# Service Manual

*Supplement*

**KX-TS2388CAB/KX-TS2388CAW/  
KX-TS2388RUB/KX-TS2388RUW/  
KX-TS2388UAB/KX-TS2388UAW/  
KX-TS880B/KX-TS880W/  
KX-TS880LXB/KX-TS880LXW/  
KX-TS880MLW/KX-TS880MXB/  
KX-TS880MXW/KX-TS880NDB/  
KX-TS880NDW/KX-TS880SAW/  
KX-TS881MXB/KX-TS881MXW/  
KX-TS889MXW/KX-TS108W**

Integrated Telephone System

NC: No Components  
 KX-TS889 SCHEMATIC DIAGRAM (Main)

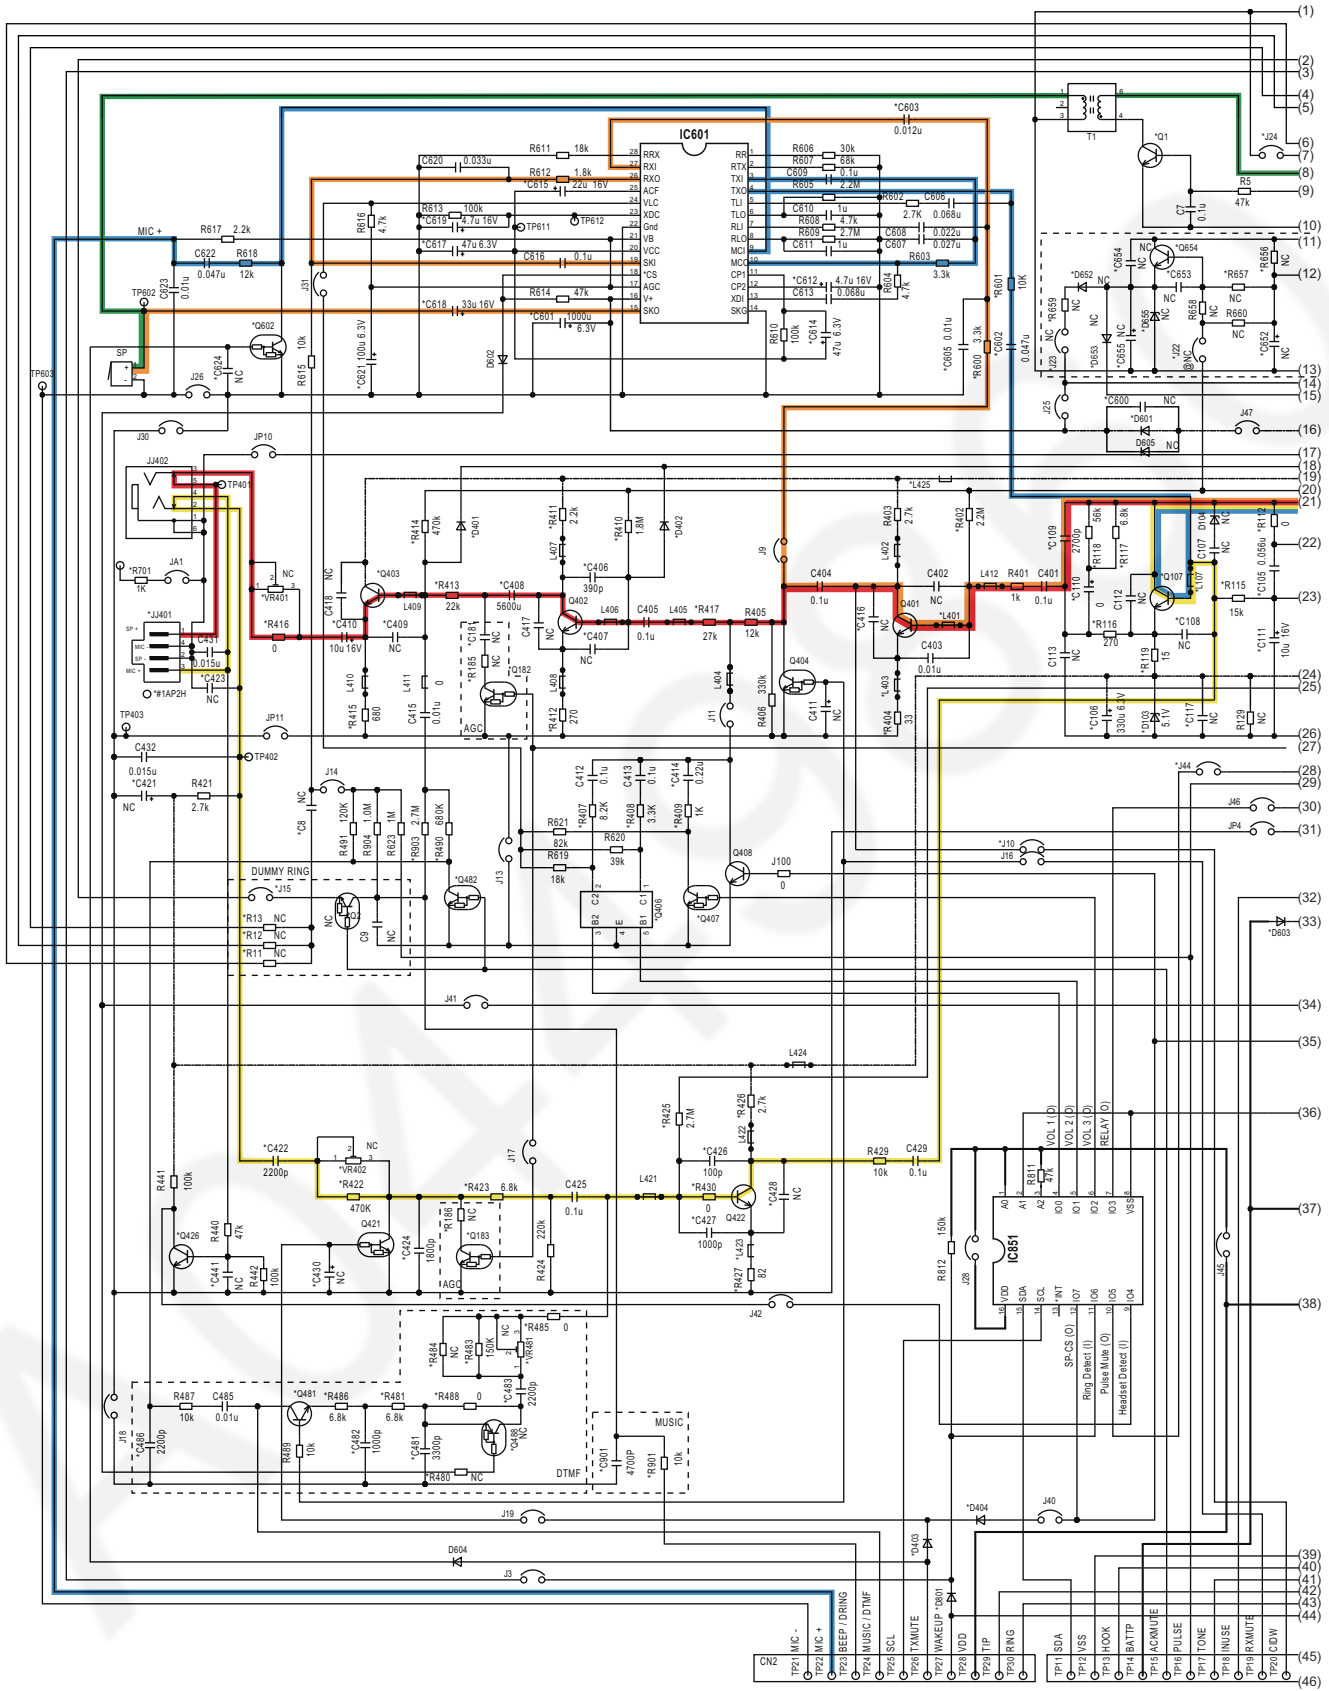
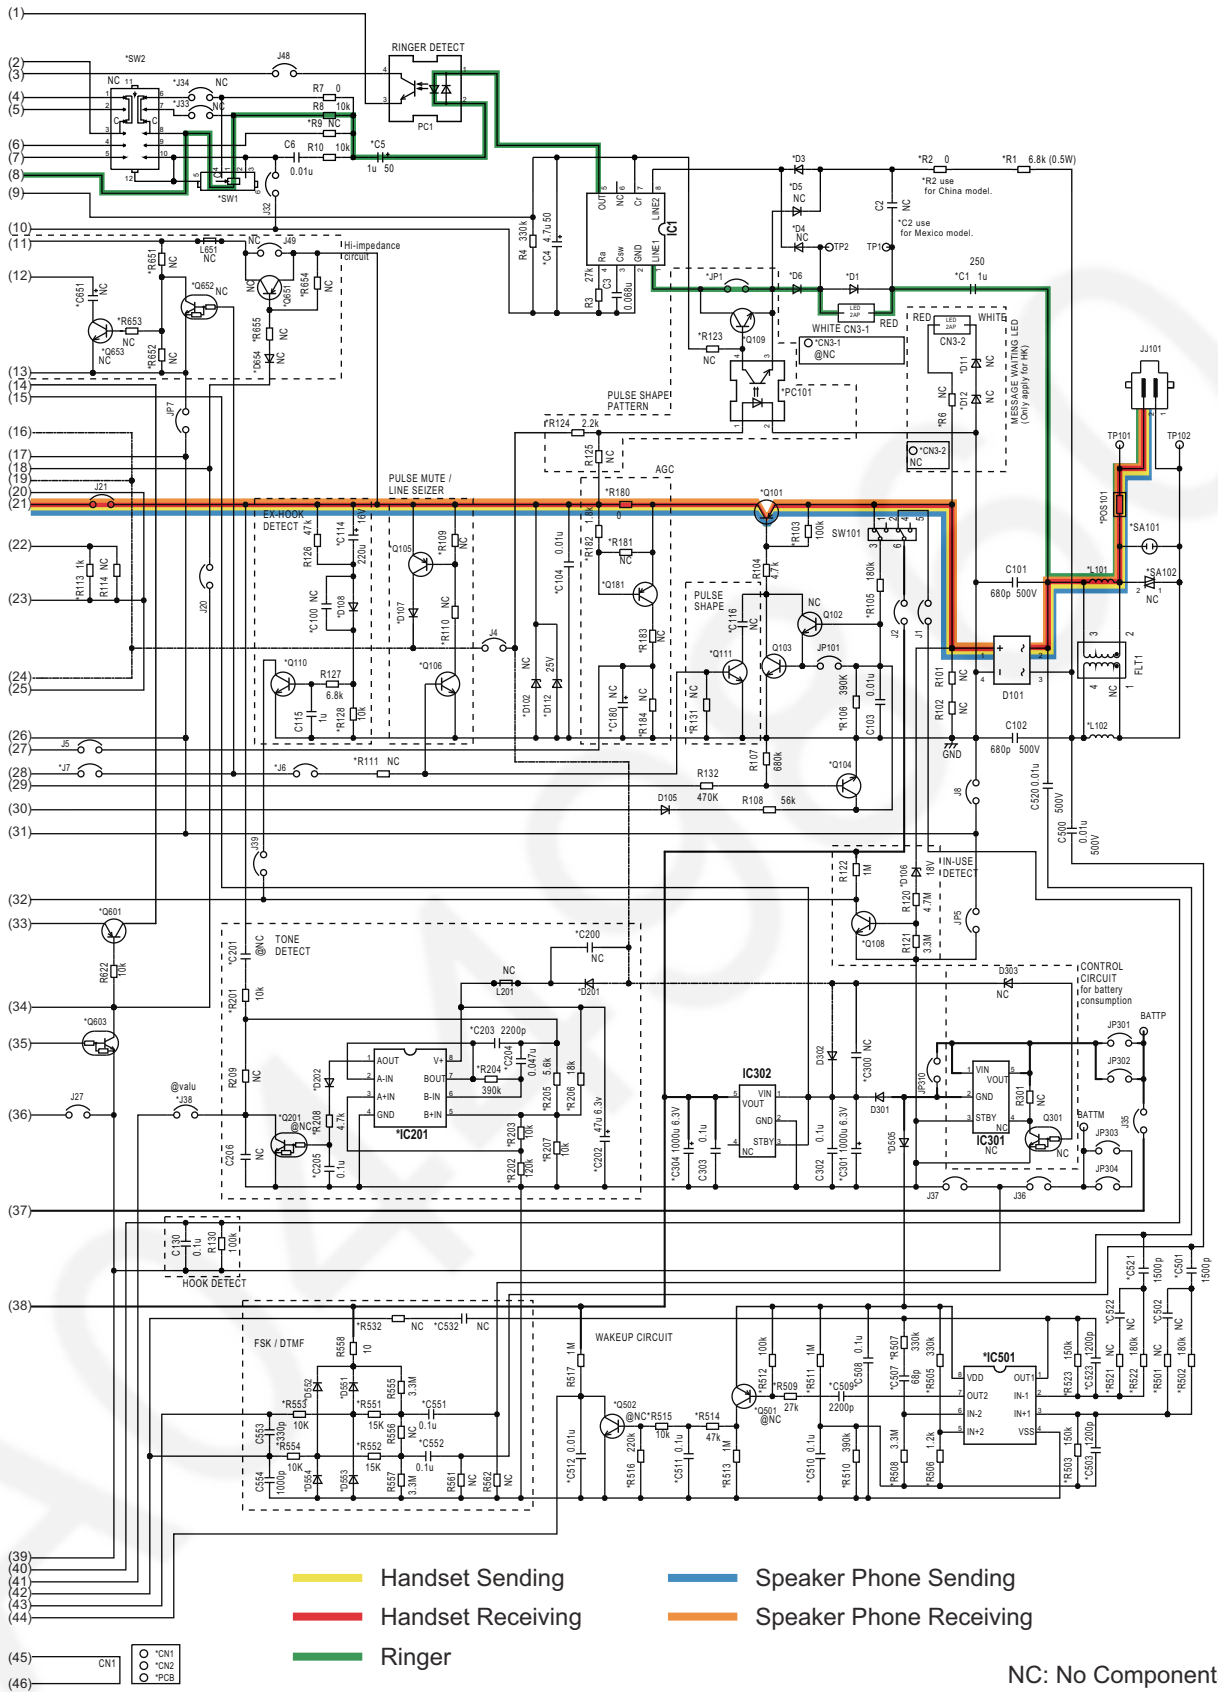
[Changed from original section "11.2. Schematic Diagram (Main)"]

KX-TS108 SCHEMATIC DIAGRAM (Main)

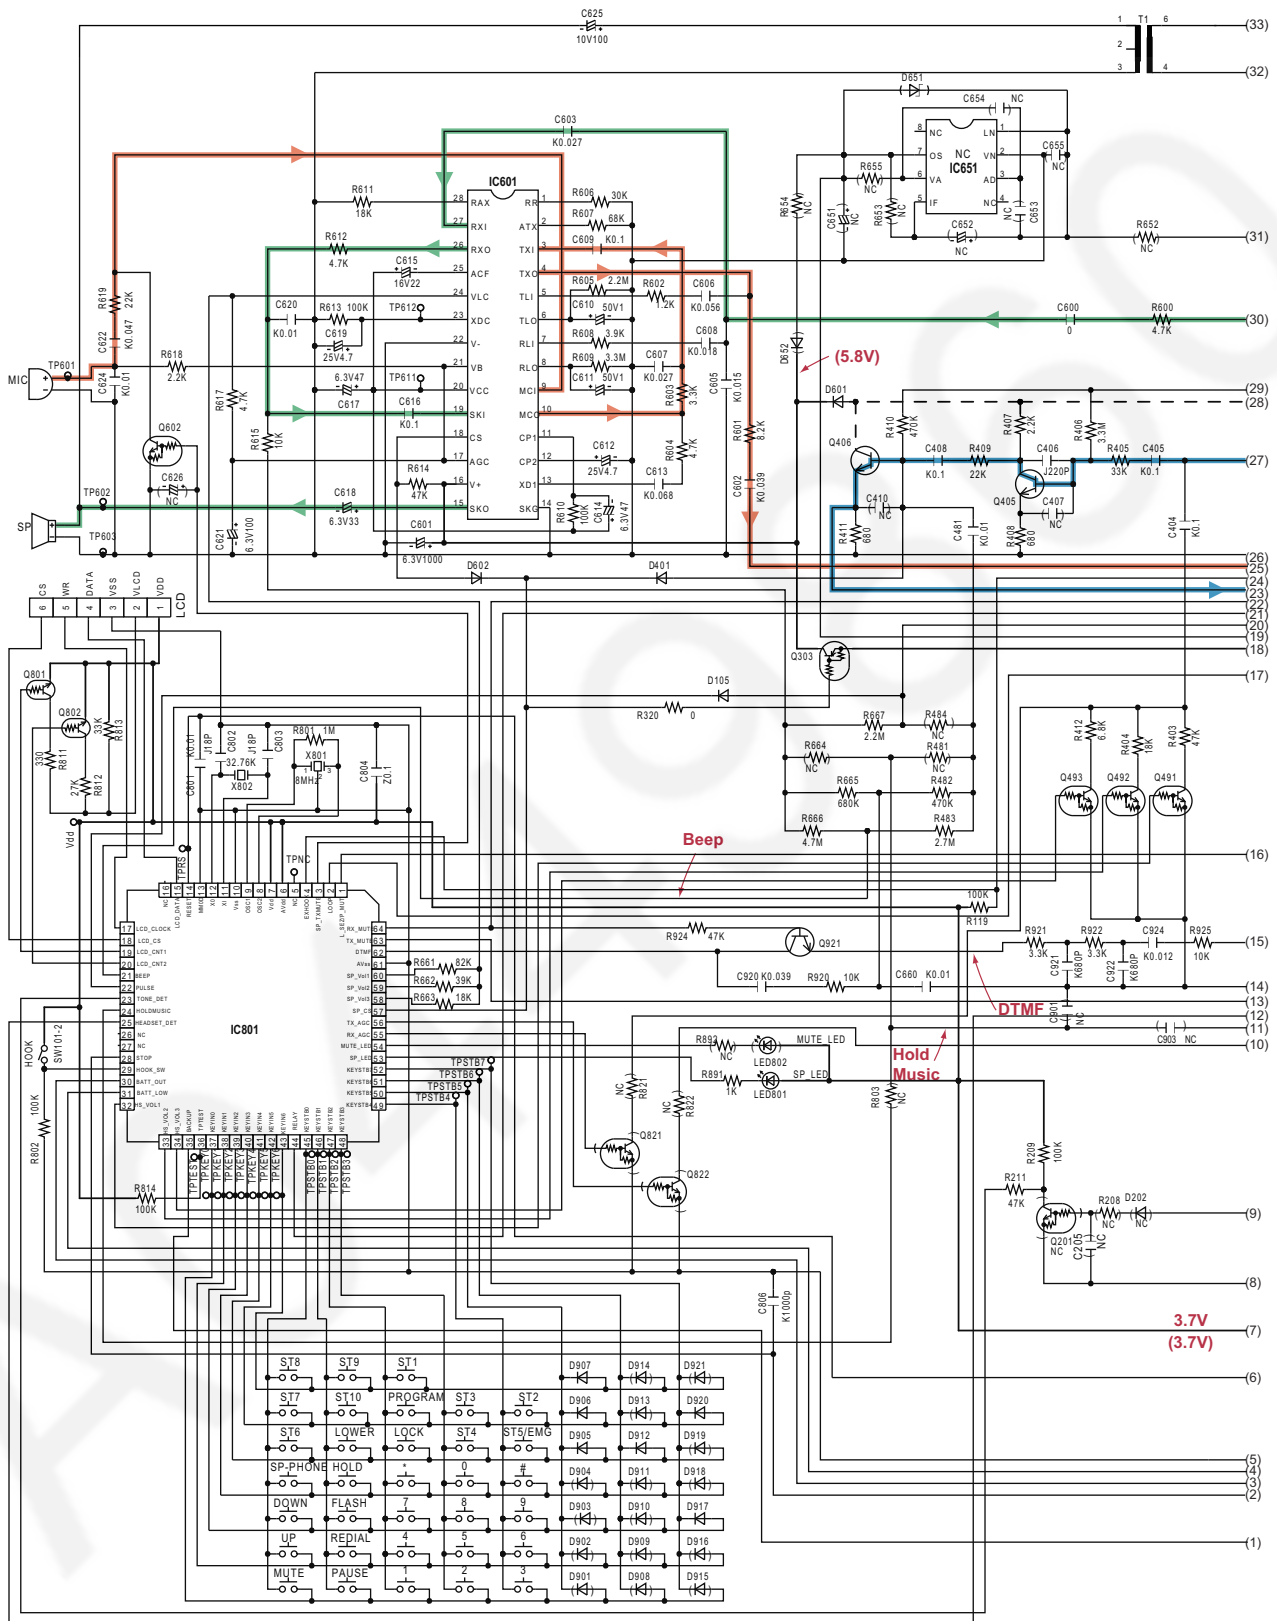
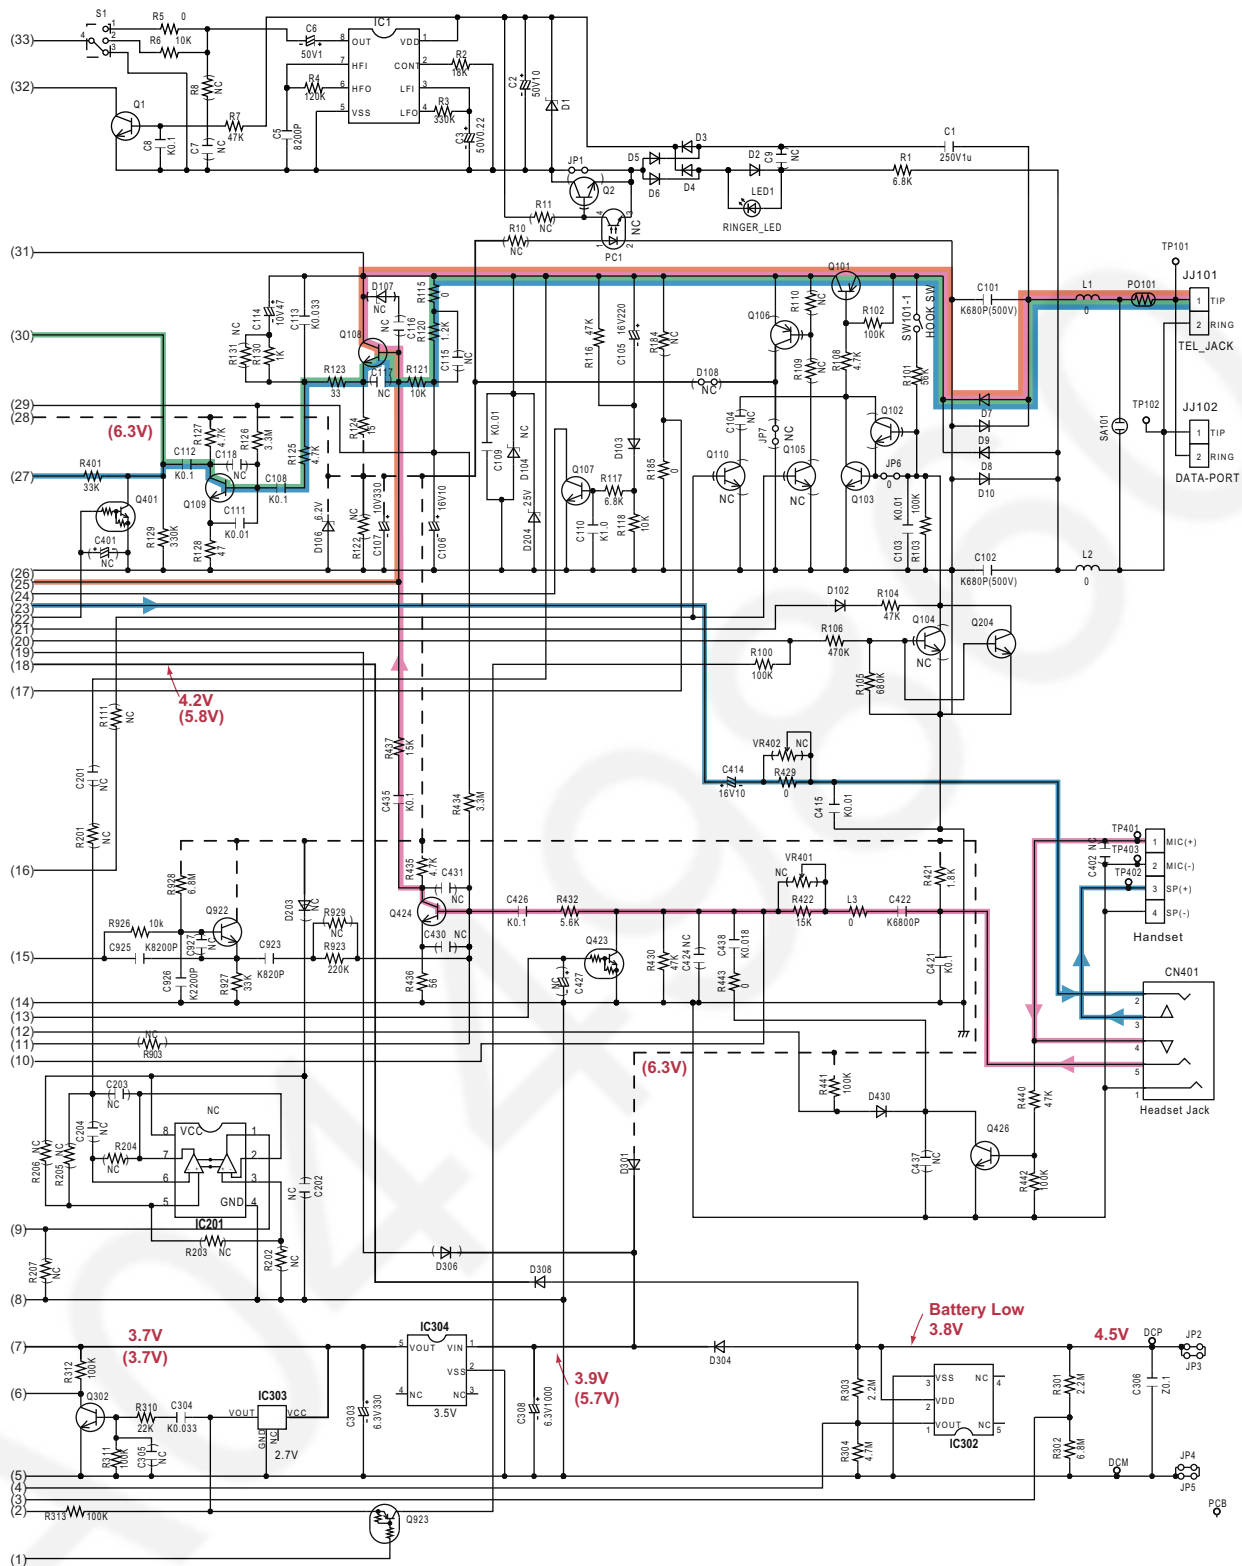
[Changed from original section "5 CHEMATIC DIAGRAM"]

KX-TS880/881/889/2388 CIRCUIT BOARD (Main (Component View))

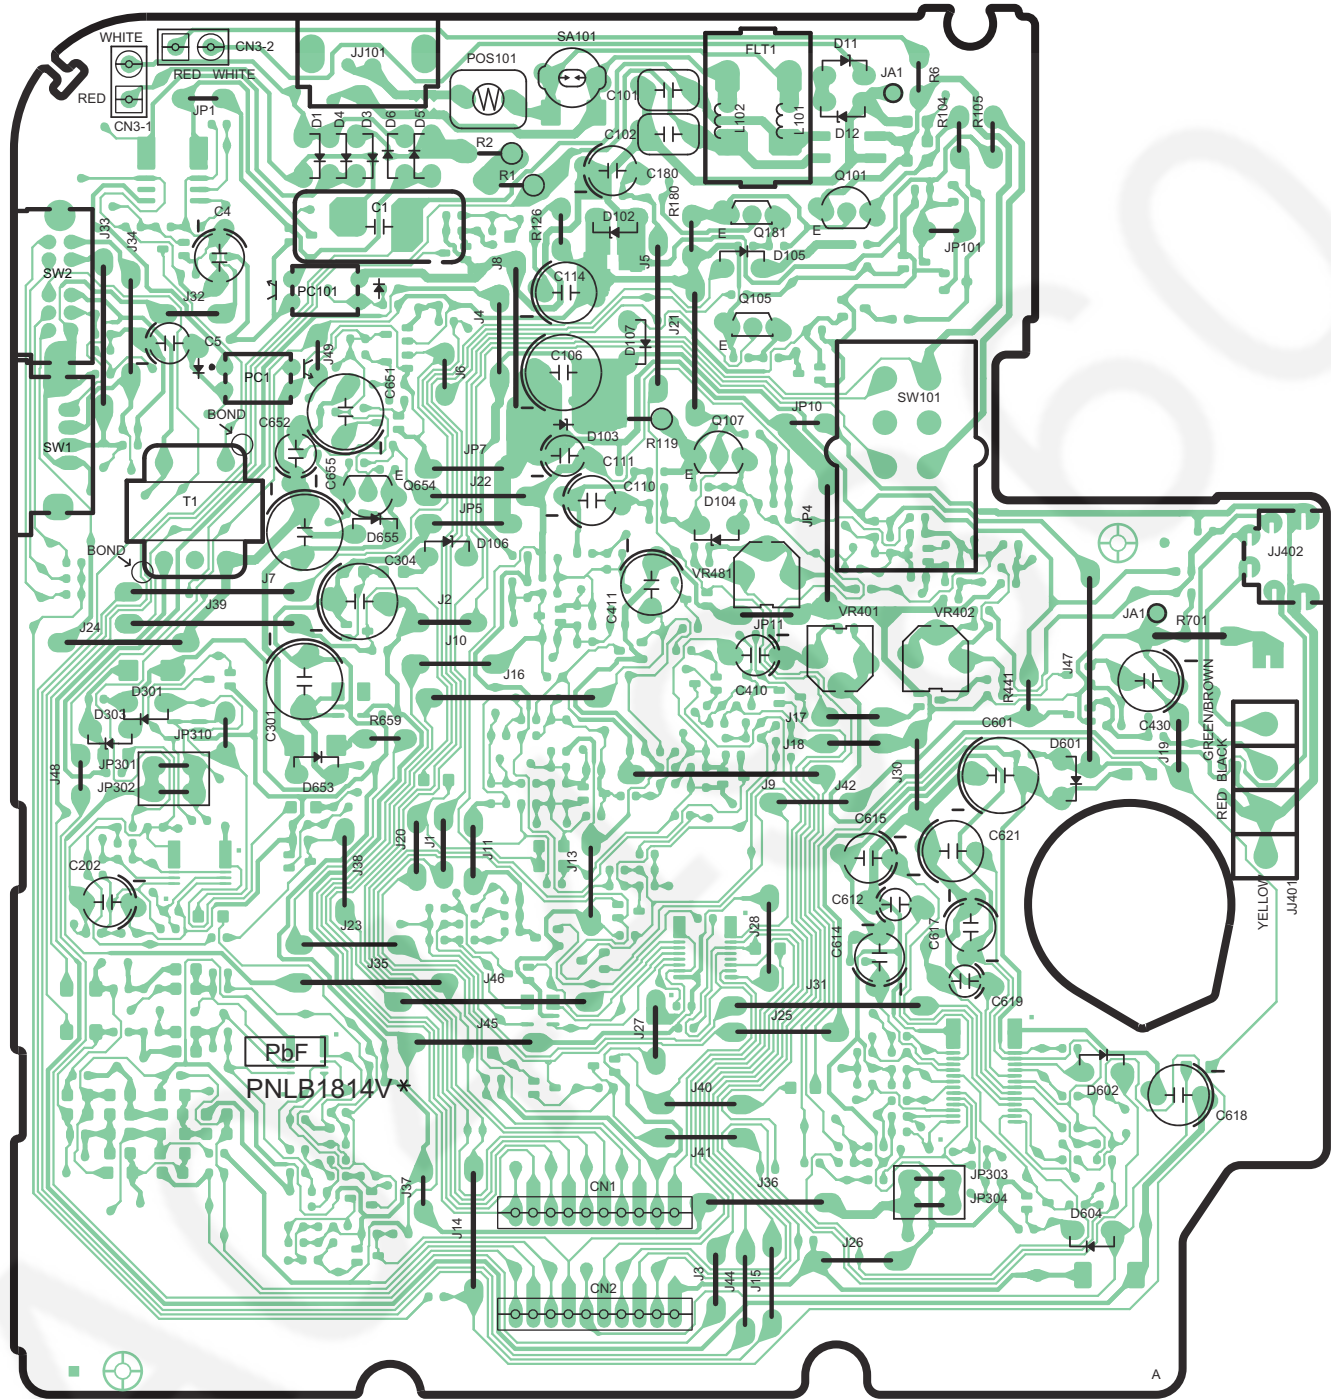
[Changed from original section "12.1.1. Component View"]
